Re: Additional information and amendment to DP 4830

Sisk Mountain

Proposed Meteorological Tower Site and Access Wetlands and Streams

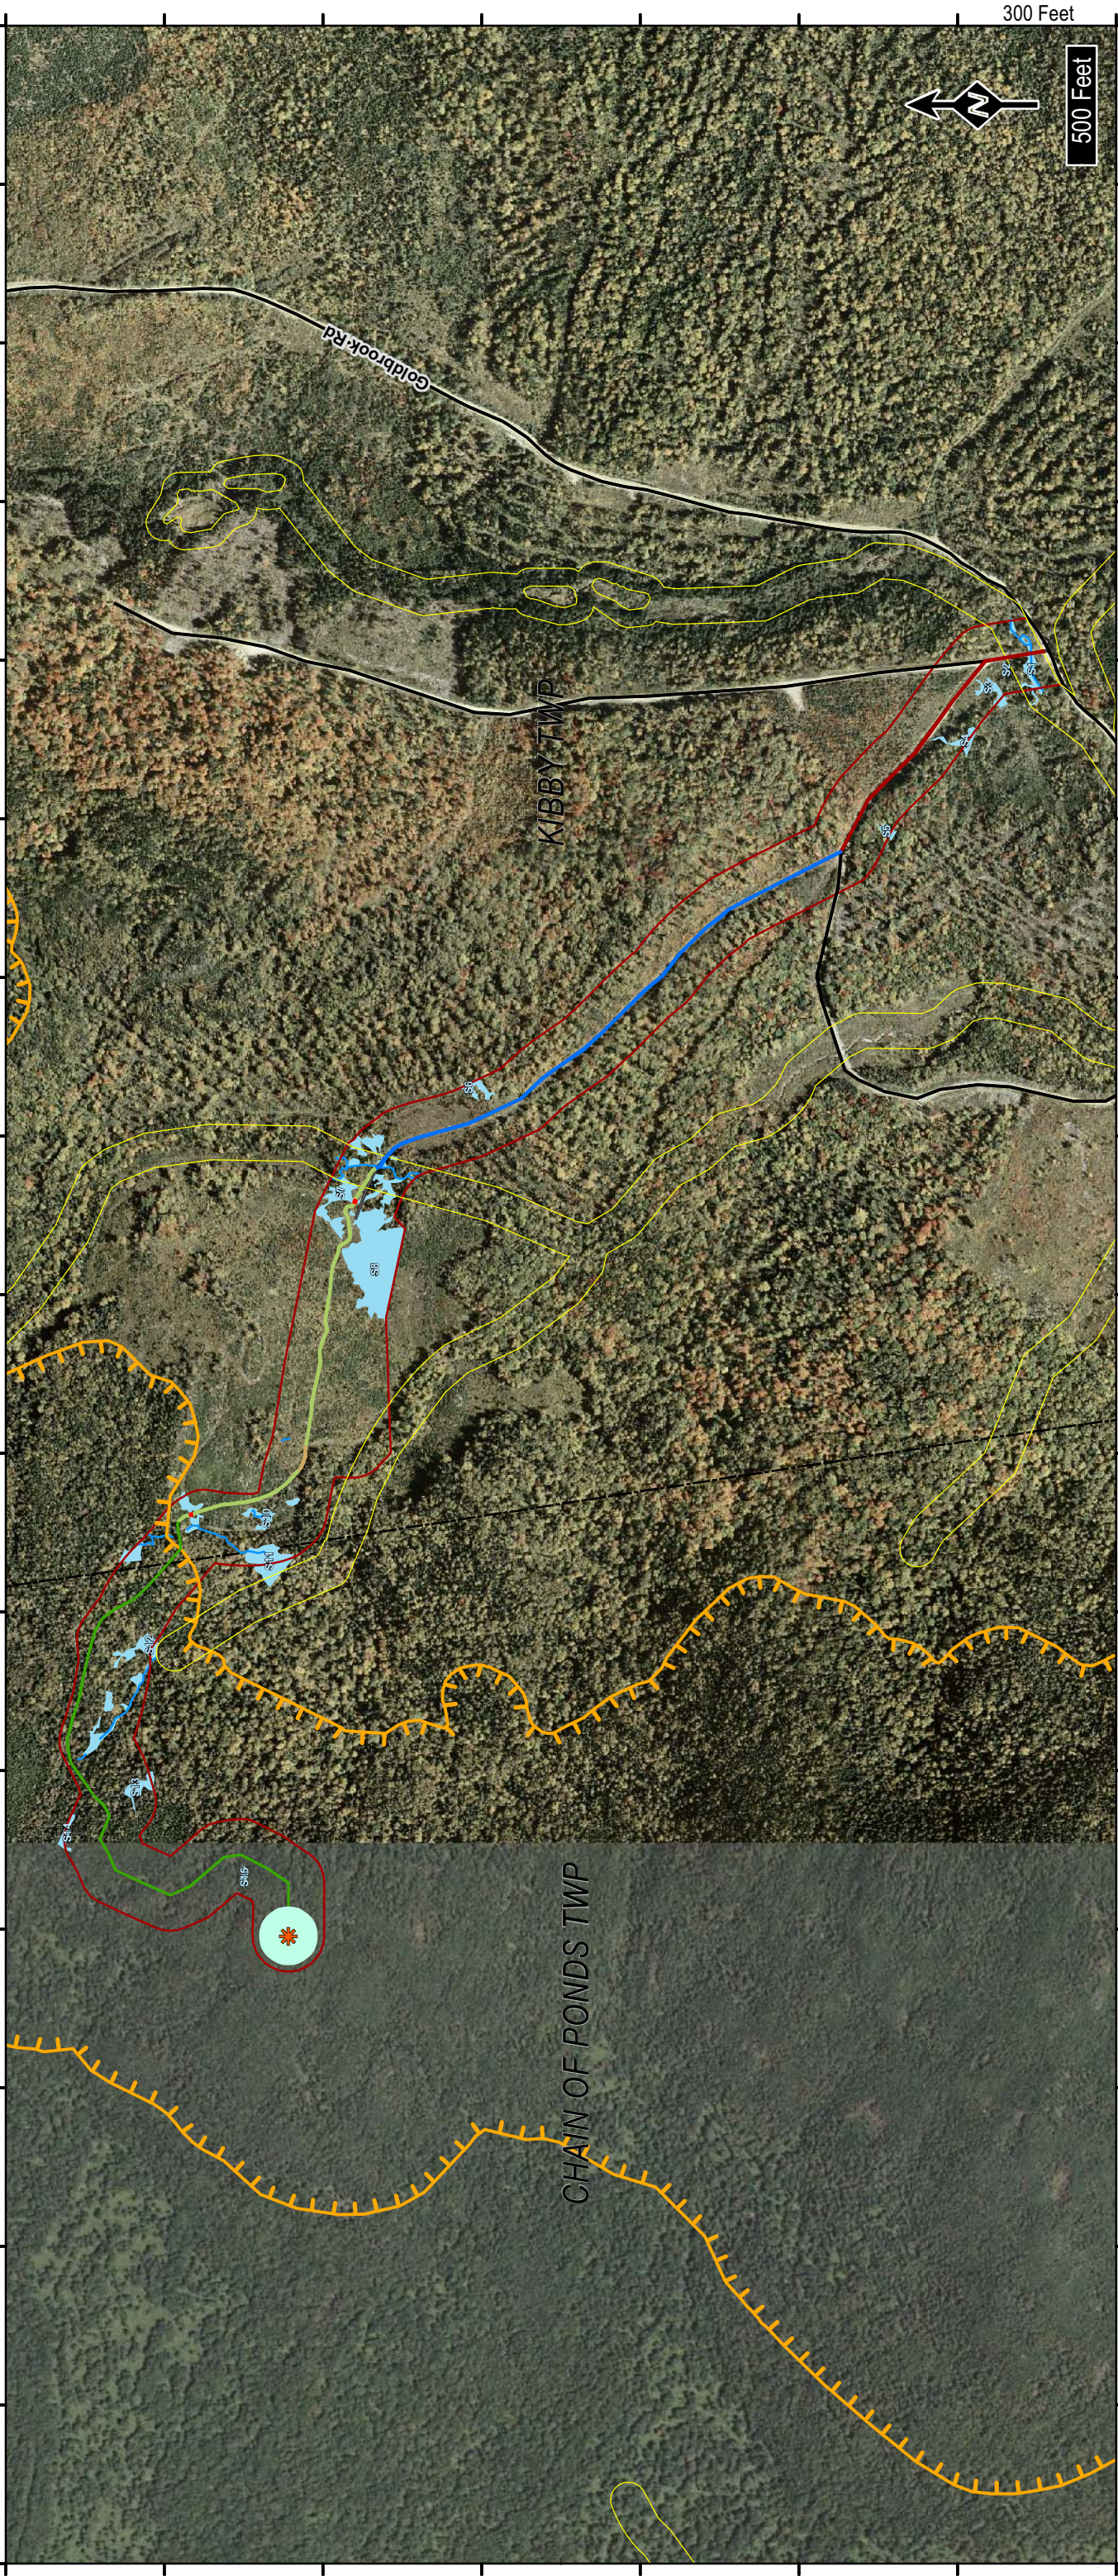
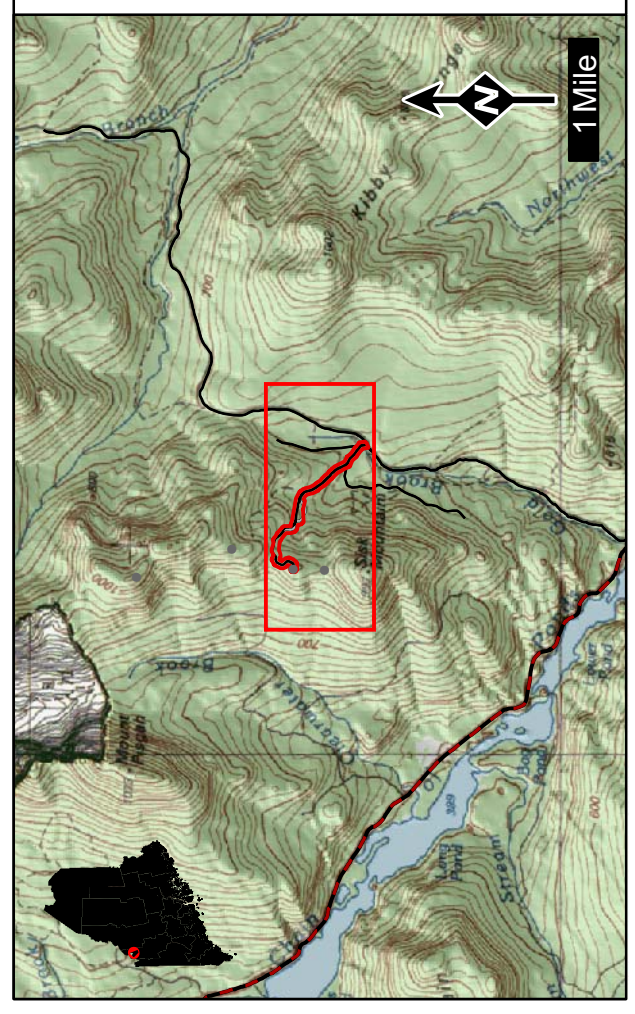
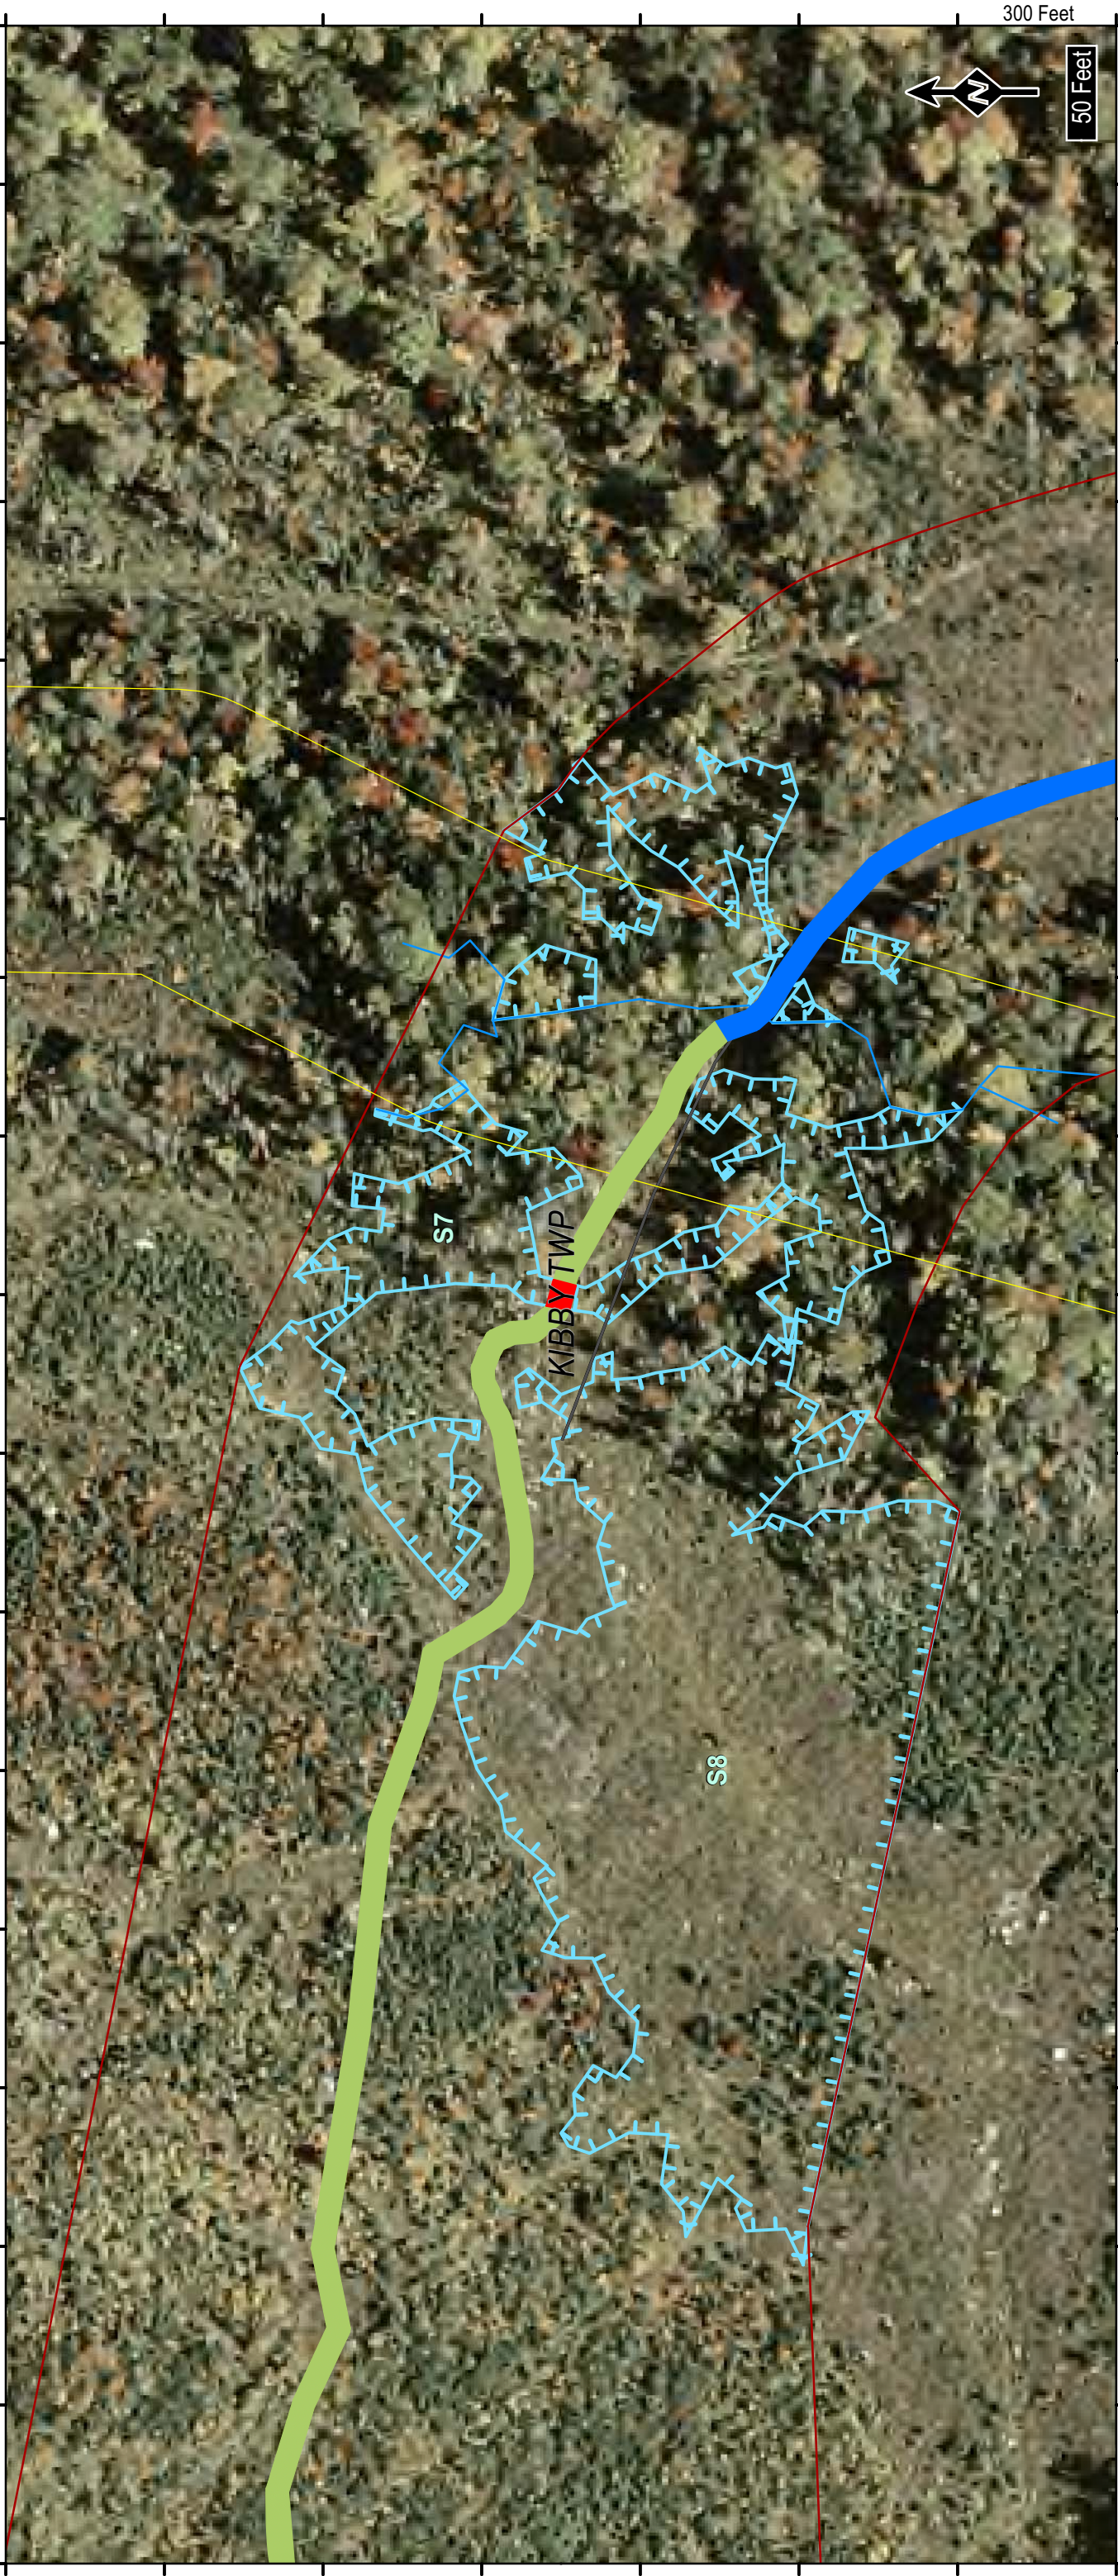
TransCanada is providing the following additional information in support of DP 4830: A modification of the application to reduce the number of met towers from 4 to 1, with an attendant reduction in necessary access trails along the ridge; wetland delineation data mapping and a realignment of the primary access trail to minimize wetland impact; and a Phase 1A archaeological survey report. The trail width has also been reduced to 12 feet and a revised Exhibit A to the Special Use Agreement with Plum Creek, reflecting the current proposal and realignment, is also included.

As a result of the soil and wetland delineation work, wetland impact has been kept to a minimum, and the trail has been realigned to avoid wetland impact to the extent possible. Two different scrub shrub (P-WL2) wetland areas found in a regenerating clear cut on the lower slopes of the mountain will be crossed with equipment mats. The impact areas total approximately 276 square feet, or 0.006 acre of temporary wetland impact. See the attached detailed maps depicting the trail and wetland impact areas. Also attached is a revised Supplement S-3. As described in the original application, there will be a temporary bridge placed for a trail stream crossing. The crossing is along the existing winter road and is at the former site of a culvert/bridge crossing used for timber harvesting in the area. This has not changed from the original application. Trail area within the P-SL2 subdistrict associated with this stream is 2,006 square feet or 0.05 acre.

TransCanada would also like to amend the current application to include only one met tower and associated trail. The trail and met tower site will also be used for geotechnical investigations. The total cleared area will be reduced by 3.92 acres from 6.25 acres to 2.33 acres of clearing. Total linear distance of trail along the ridge line will be reduced by 1.6 miles. If it becomes necessary to install one or more of the remaining three towers, TransCanada will provide additional wetland delineation data as necessary and seek the necessary approvals to do so at that time. Of this total cleared area, approximately 1.77 acres of clearing is in Chain of Ponds Twp and 0.56 acres is in Kibby Twp. The length of the newly proposed trail is 1.56 miles, made up of existing gravel road (0.24 mile), winter

road (0.46 mile), skidder trail (0.02 mile), new trail in recently cut regeneration area (0.35 mile), and new trail in forested area (0.5 mile). The vicinity of the site has been cut recently up to 2,700 feet in elevation, so the new trail in forested area is almost entirely above 2,700 feet. Total area that will require clearing above 2,700 feet is 1.79 acres, which includes trail area and the met tower clearing. See the attached location and foot print maps, which include tables with trail lengths and areas.
